City of Fredericksburg

Planning and Zoning Meeting Agenda
Wednesday, September 4, 2024 ~ 5:30 PM
Law Enforcement Center
1601 E. Main Street
Fredericksburg, Texas 78624

CAPTION: SP-2408 - Site Plan and Entry Corridor Review for a General Retail Development Located at 736 South Washington Street.

RE: SP-2408, Review Comments for the Site Plan and Entry Corridor review of the Retail Development Located at 736 South Washington.

SITE PLAN

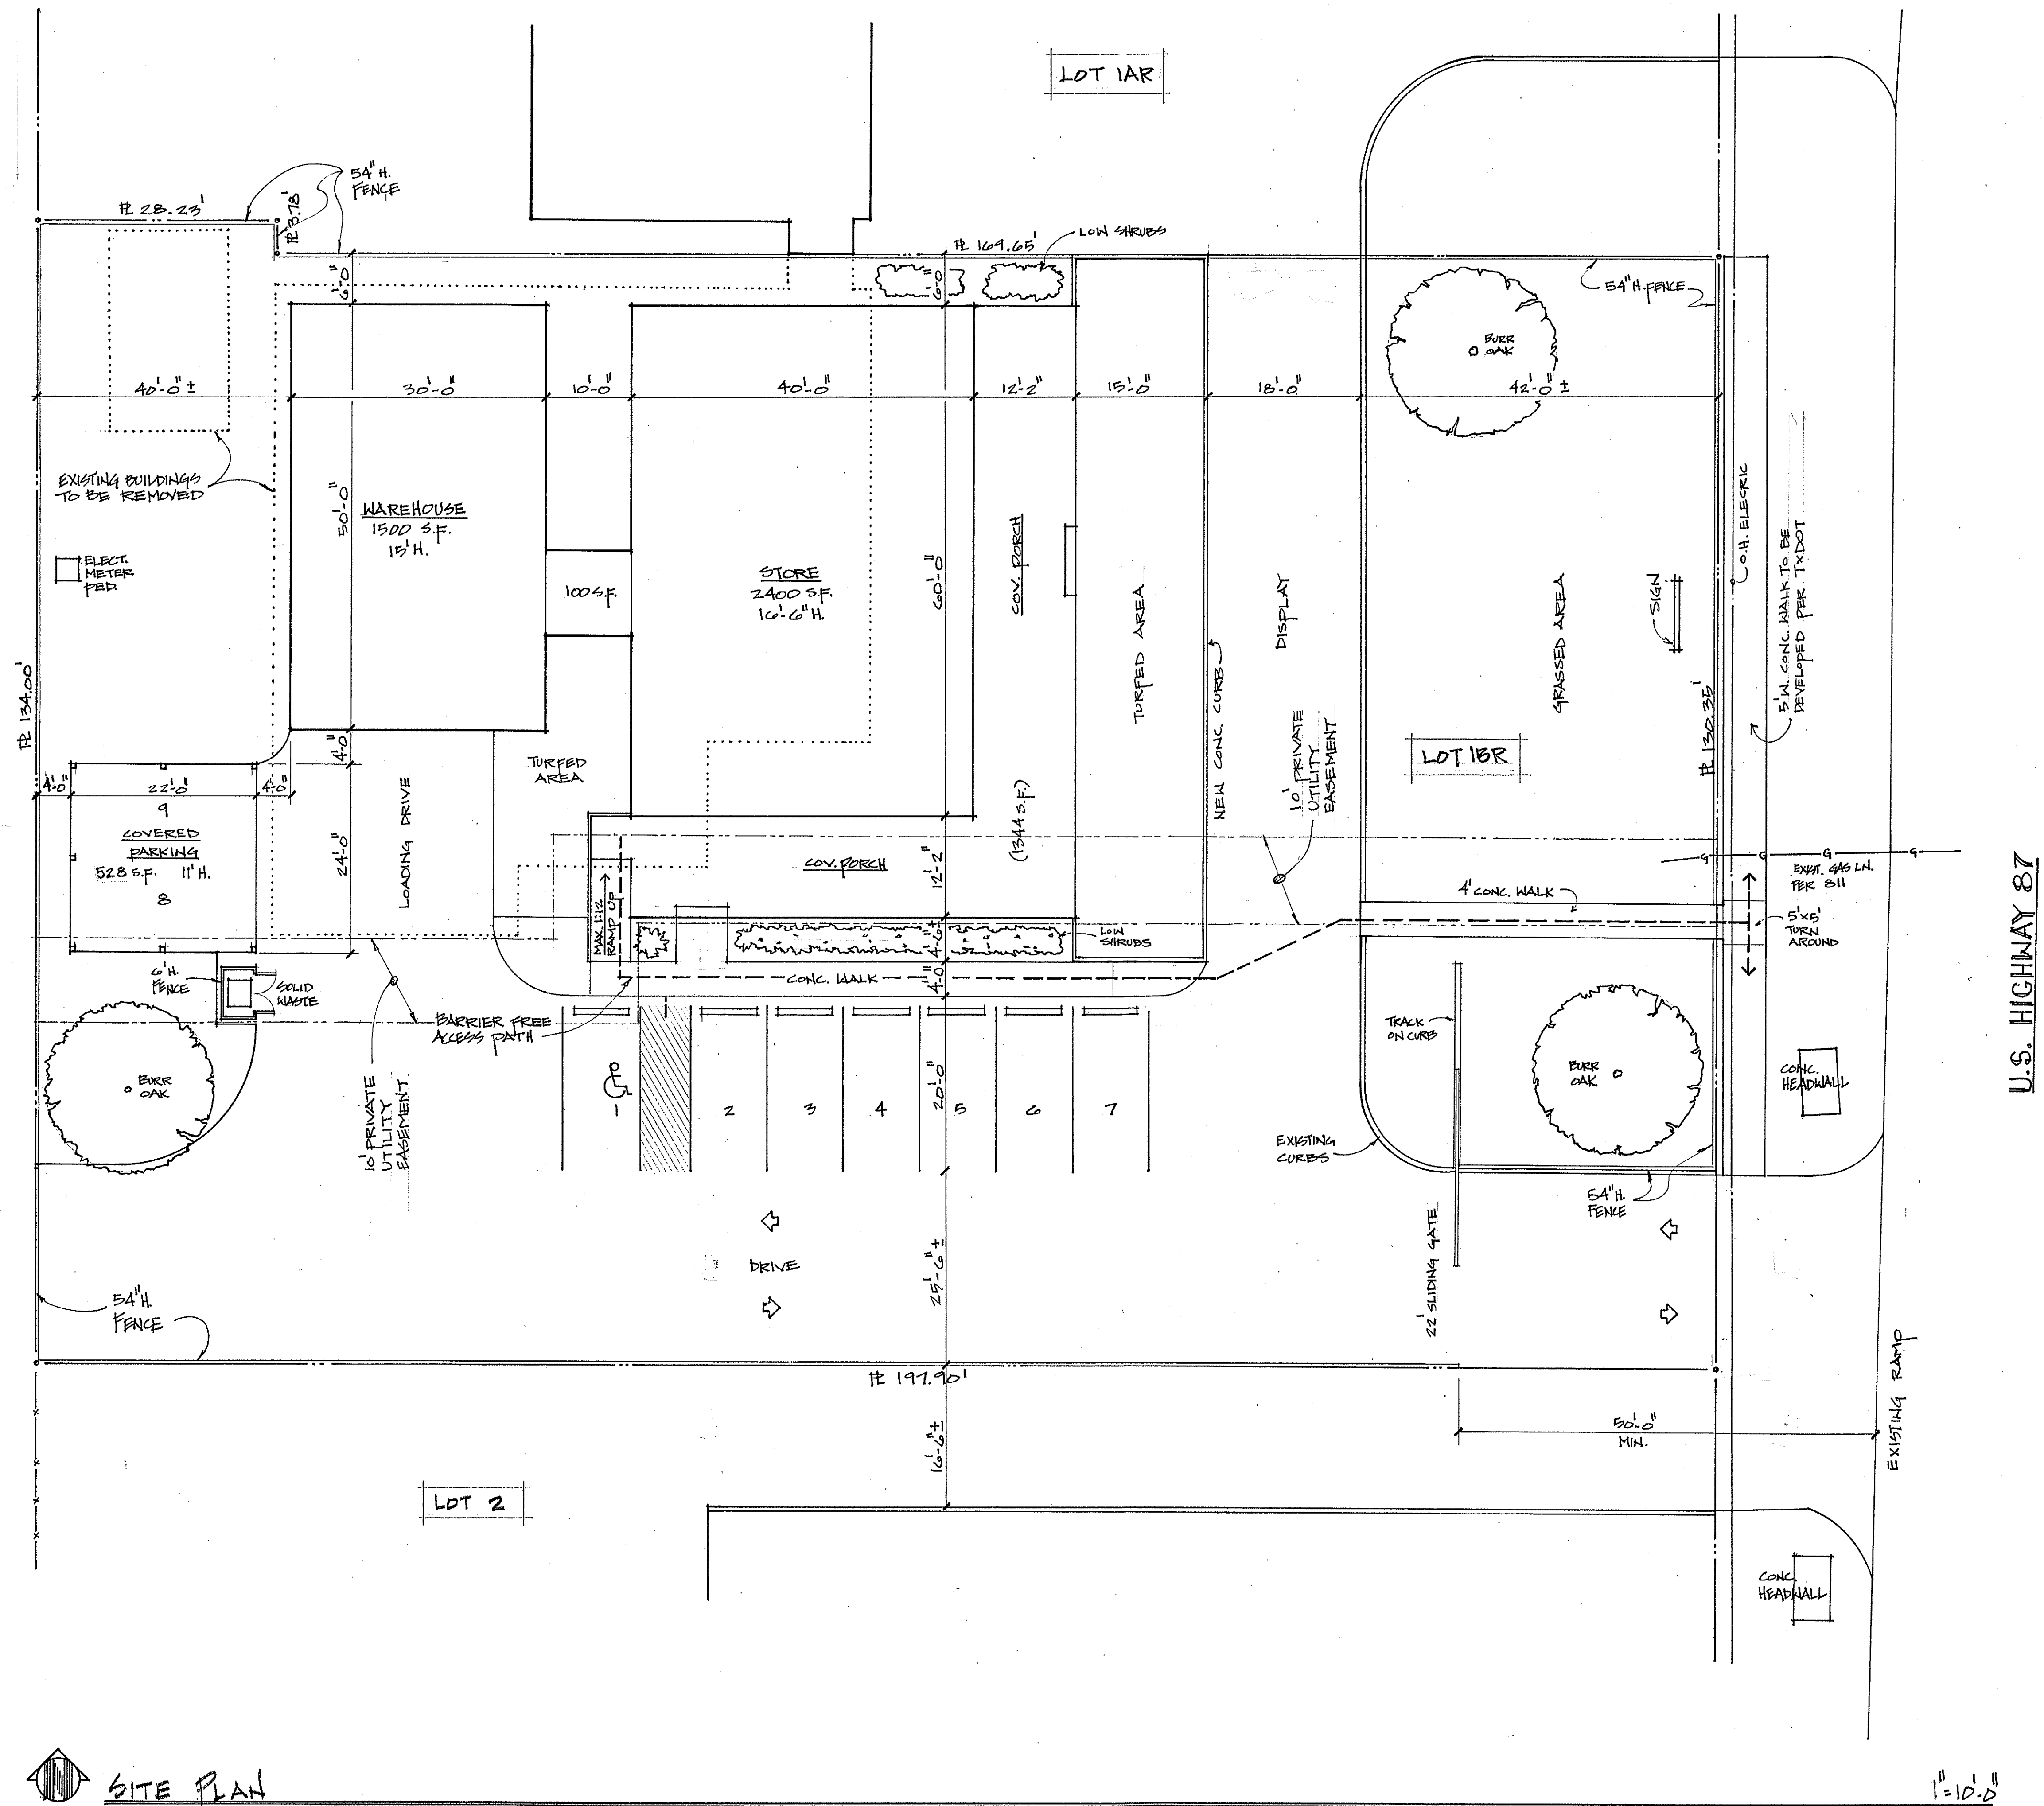
- Show private utility easement from Vol. 3 Pg. 117 plat records.
- Provide updated TxDOT driveway permit.
- The 4' wide sidewalk coming off the public sidewalk requires a 5 ft x 5 ft turn-around every 200 feet.
- Any additional impervious cover from existing will require detention.
- Show existing utilities
- Show flow arrows indicating the direction of stormwater runoff on the site
- Review the lot area, it differs from the lot area shown on Vol. 3 Pg. 150 plat records.

- The 4' wide sidewalk coming off the public sidewalk requires a 5 ft x 5 ft turn-around every 200 feet.
 - *A 5'x5' turnaround is shown on the public sidewalk on the architectural site plan. The location provided meets the 200' requirement.*

- Any additional impervious cover from existing will require detention.
 - *We have noted the detention requirements. The current architectural site plan includes less impervious cover than the existing site.*

- Show existing utilities
 - *We have shown the existing site utilities on Exhibit 1A.*
- Show flow arrows indicating the direction of stormwater runoff on the site.
 - *We have added drainage arrows on Exhibit 1A per the topographic survey that has been completed. Development of the site will follow similar patterns and will be detailed in pre development and post development drainage area maps.*
- Review the lot area, it differs from the lot area shown on Vol. 3 Pg. 150 plat records.
 - *The area has been corrected on the current architectural site plan.*
